Engineering Bulletin #105 Encoder Faults

O. Thompson Co.

Slowdown Failure Fault

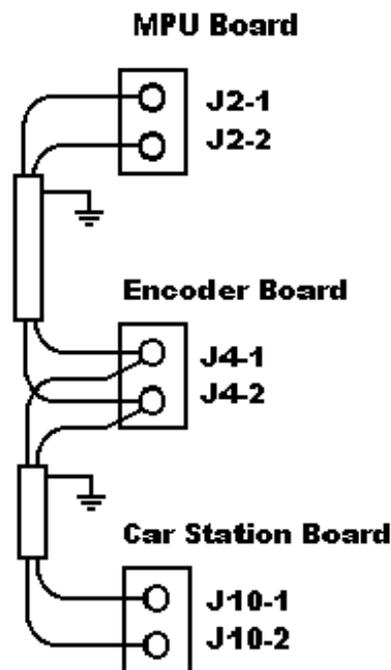
On older version of the Encoder PC board, this fault may occur erroneously. Boards that are Revision level A through E are effected. On version 'F' and later, there is not a problem.

If you have an Encoder board which is one of these versions, the board can easily be modified to eliminate the problem. Resistors R12 and R13 should be changed from 2.2 K ohm to 470 ohm. This can be accomplished in the field. Remove power from the controller, and access the car top. Clip the existing R12 and R13 resistors off the board, leaving enough wire to solder the new resistors to. Solder the 470 ohm resistor in place, and the car can be returned to service.
